## Application for Works Approval

<b>Works Approval Number</b>	W6526/2021/1
<b>Applicant</b>	Murrin Murrin Operations Pty Ltd
<b>ACN</b>	060 717 505
<b>File Number</b>	DER2021/000132
<b>Premises</b>	Murrin Murrin North Murrin Murrin Nickel Cobalt Project  Legal description - Mining tenements M39/342, M39/343, M39/553, M39/424, M39/421 Shire of Leonora and Shire of Laverton
<b>Date of Report</b>	26 July 2021
<b>Decision</b>	Works approval granted

Figure 4 Groundwater monitoring bore locations

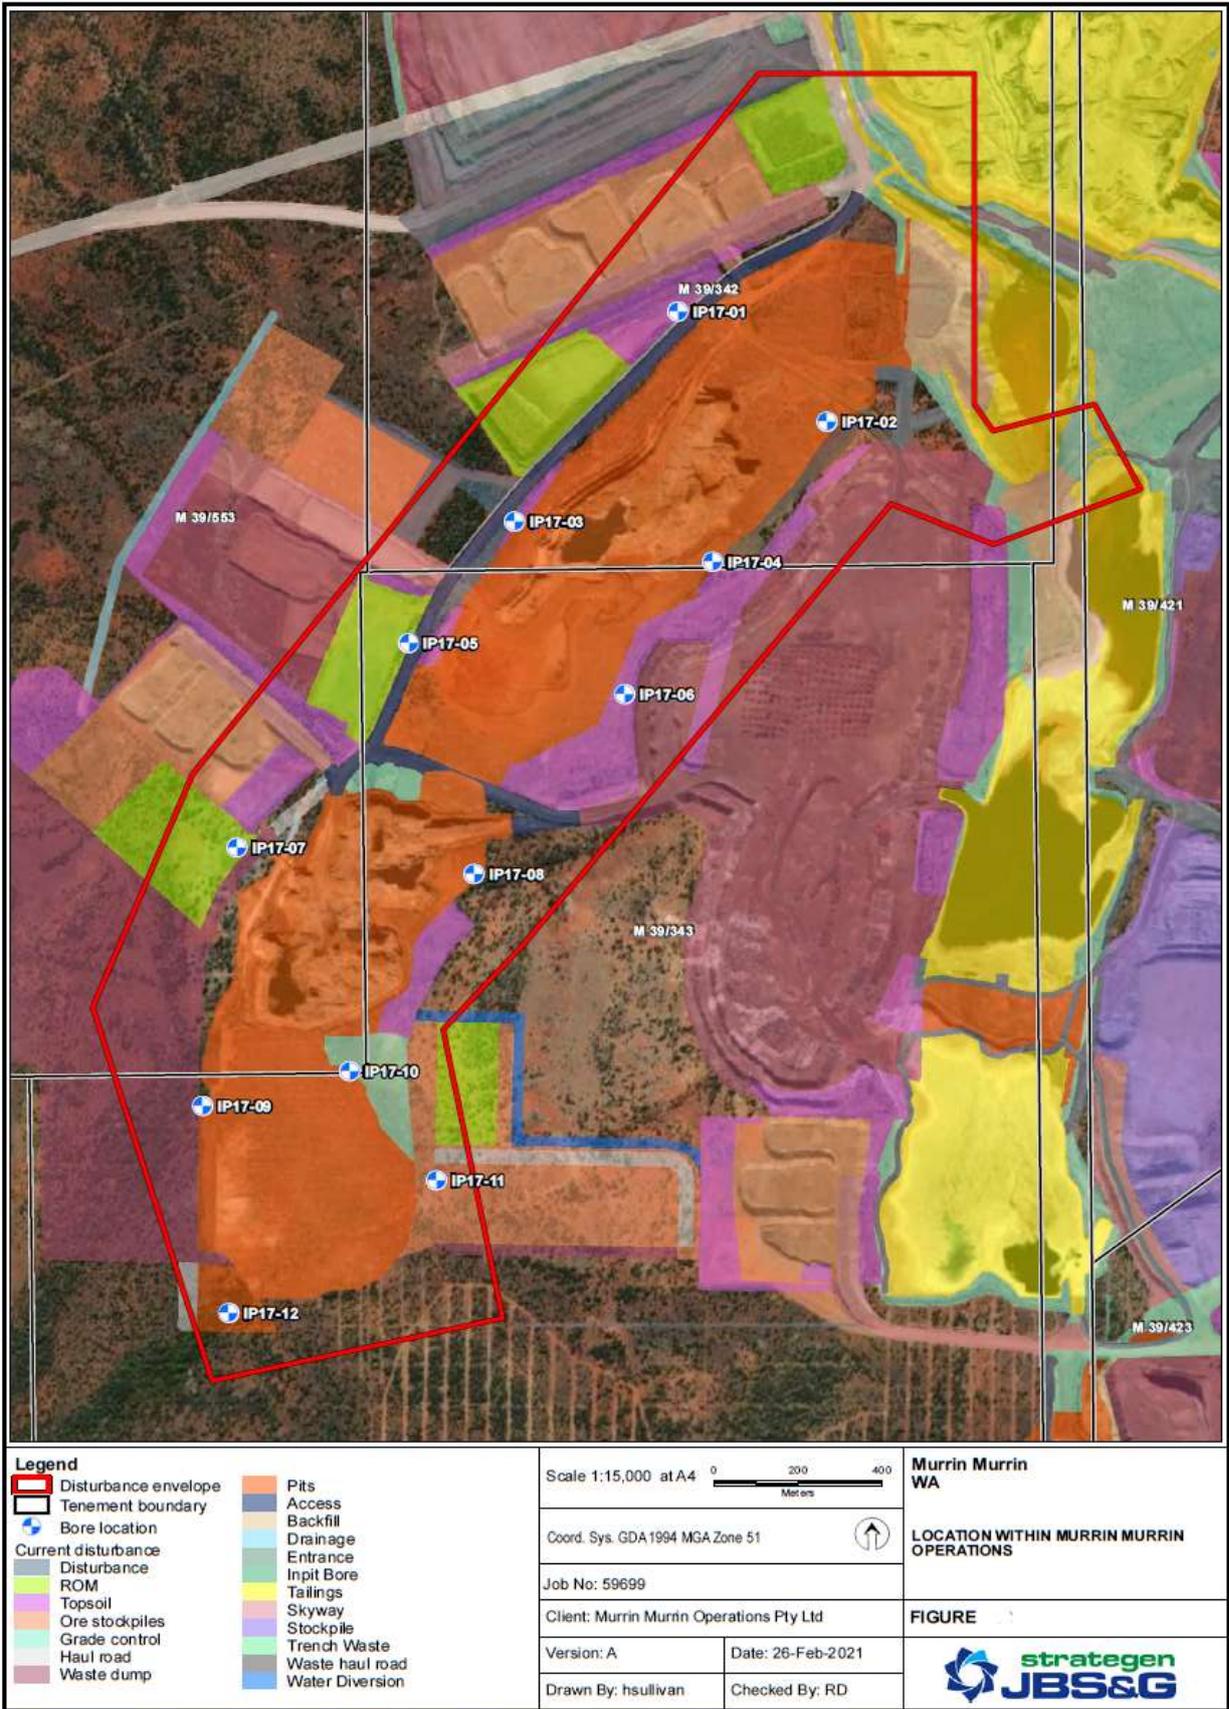
According to hydrogeological investigations provided in supporting documents, the premises area shows relatively low hydraulic conductivity and movement of seepage to be restricted to discrete hydraulic pathways within the footprint of the premises. Multiple groundwater monitoring bores have been installed in the proximity of the proposed in-pit TSFs (Figure 4) in

order to track potential seepage impacts. As a contingency plan, the applicant proposes the conversion of groundwater monitoring bores into seepage recovery bores, if seepage occurs and the standing water level limit is exceeded.

The suggested low hydraulic conductivity in the relevant area and containment of seepage within prescribed premises boundary requires confirmation via groundwater monitoring. Baseline monitoring of groundwater conditions is required to be undertaken prior deposition of tailings, to get an understanding of current groundwater quality, standing water levels and to allow future detection of potential impacts.

Standing water level limits are required to be complied with, to ensure no adverse impacts on surrounding vegetation. Standing water level limits of > 4 mbgl and monitoring of relevant parameters will be conditioned on the instrument.

The risk will be further assessed and additional controls considered as part of the licence amendment following this works approval. This could include the construction of seepage recovery bores to manage the occurring groundwater mounding.
